**3 Baynes Mews London NW3 5BH**

**Minor Material Amendments  
Planning Statement**

The report outlines the summary of the proposed minor-material amendments to the planning permission 2023/1043/P which includes changes to the ground floor's garage doors and to the roof-lights.

Proposed Front Facade - Proportions and elements

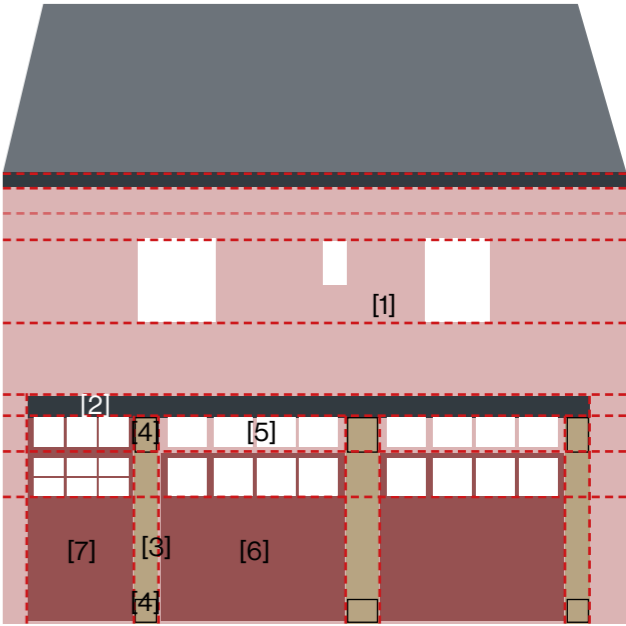
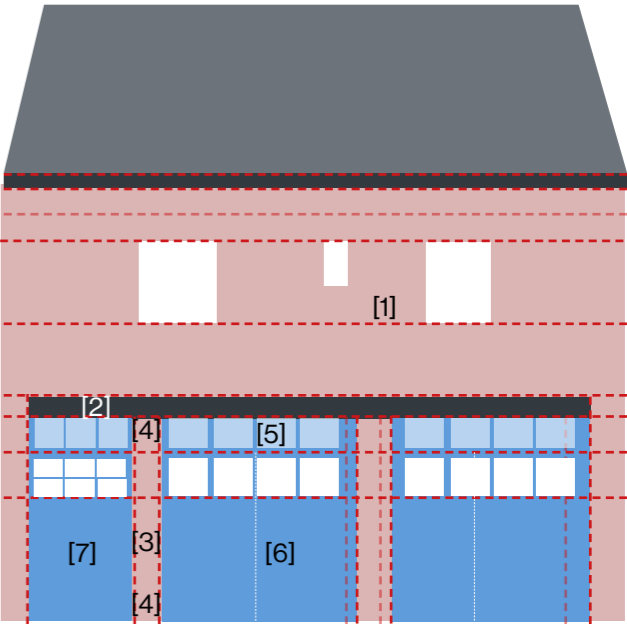
The approved design under planning applications Ref: 2023/1043/P & 2023/4925/P includes reducing the height of the sash windows on the First floor [1]. The existing cornice [2] is to be replaced with a new similar element, rendered and weatherproofed. The softwood [3] casings and decorative elements [4] proposed to be repaired. The top series of windows [5] is to be blocked with the lowered first floor, and an obscured window row will be installed to conceal the floor slab behind. The existing garage doors [6] are to be repaired, keeping the top windows row. The entrance door [7] is to be replaced with a slightly broader and more accessible door. The glazed panel above the door will be replaced with obscured glass to conceal the floor slab behind, aligning with the garage door row of windows.

The proposed amendments to the consented application seek to preserve its current proportions and layout principles while upgrading the existing garage doors to ones that align with the overall appearance of neighbouring houses, and provide appropriate thermal and acoustic insulation. These new doors [6] will be timber-painted blue-hinged doors, similar to No 4, with an open-able top window panel to facilitate better natural air ventilation to the liveable space on the ground floor. Additionally, they will be soundproofed and weatherproofed to comply with modern residential standards. The softwood [3] casings and decorative elements [4] are proposed to be removed while keeping the original facade proportions.

Approved Roof Plan (2023/4925/P)

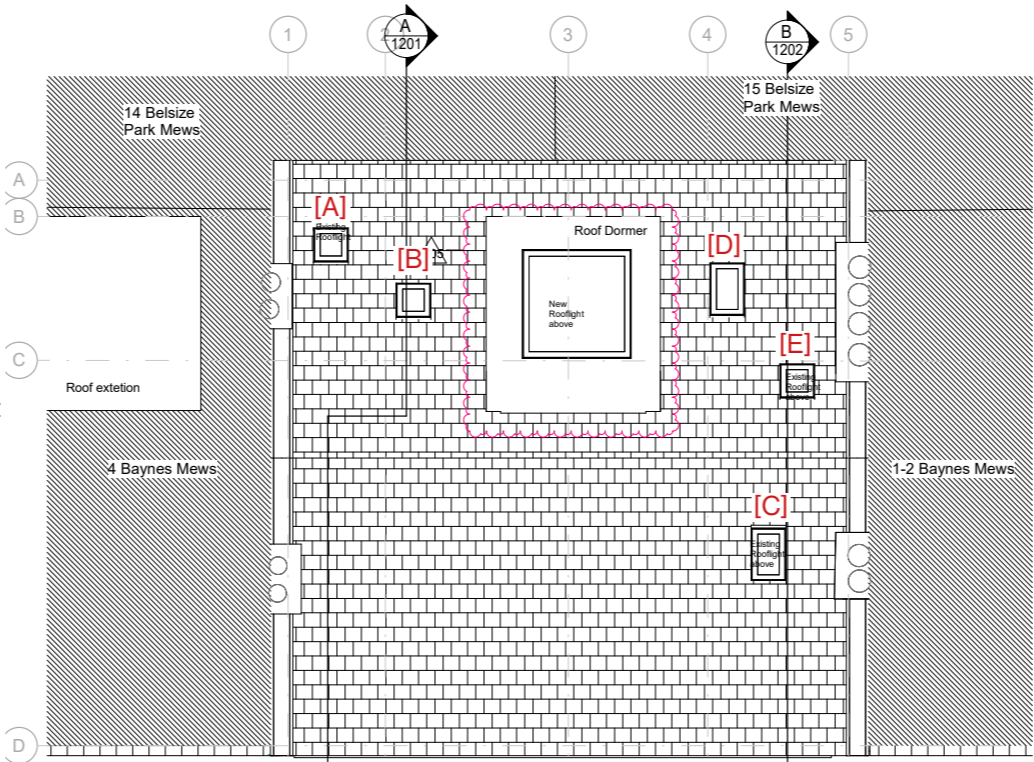
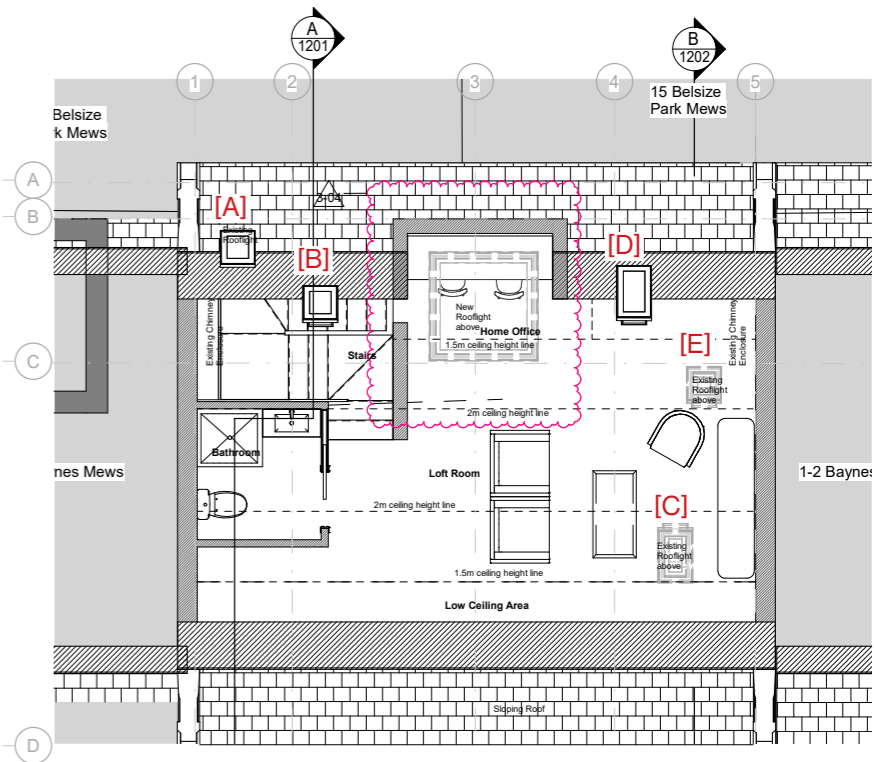
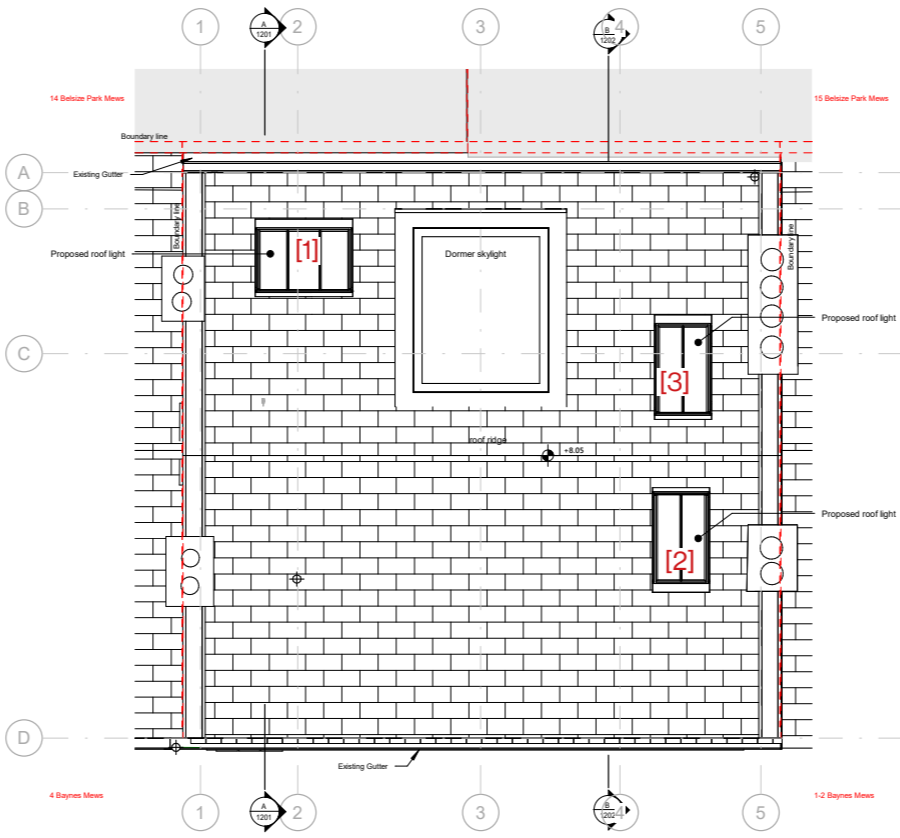
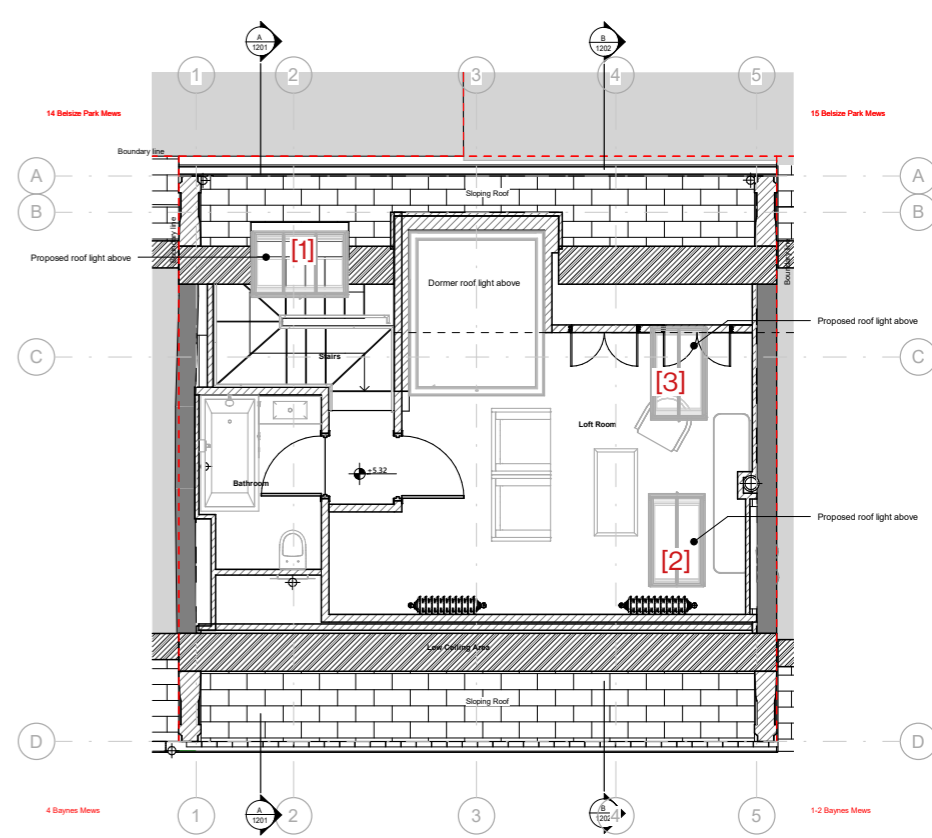
The approved design ( 2023/4925/P ) included a rear roof dormer to maximise the usable space within the loft area. This dormer featured a single roof light at the top, allowing natural light into the loft. No windows were included in the design to mitigate any potential overlooking concerns with neighbouring properties.

The current proposal suggests modifications to the existing pitched roof skylights to enhance natural light and ventilation in the loft while preserving the roof slope angle. The design involves replacing the five existing roof lights with three new ones that are compliant with building regulations and energy efficiency standards.

The first proposed skylight [1] replaces the two existing ones [A&B] above the staircase, providing ventilation and light into the stairwell, with no possibility for anyone to overlook outside.

The second proposed skylight [2] replaces the existing one [C] in the exact location but is slightly larger to accommodate Vulex sizes and optimise light and air in the space. Though visible from Baynes Mews Street, it maintains the roof's materiality and character, remaining not very noticeable from surrounding areas.

The third proposed skylight [3] mirrors the second one and replaces two existing skylights [D&E]. Positioned on the roof's rear side, it facilitates air circulation within the loft space. Its placement and angle in the roof minimise any potential overlooking of neighbouring properties.

All three proposed skylights are designed to maintain the existing roof aesthetics. They feature slim black exterior profiles and seamless glass-to-edge fittings. Their near-flush installation ensures they blend seamlessly into the roofing material, preserving the original character of the building. Their positioning takes into consideration the roof's form and other architectural elements as well as ensures a consistent rhythm throughout the roof design.
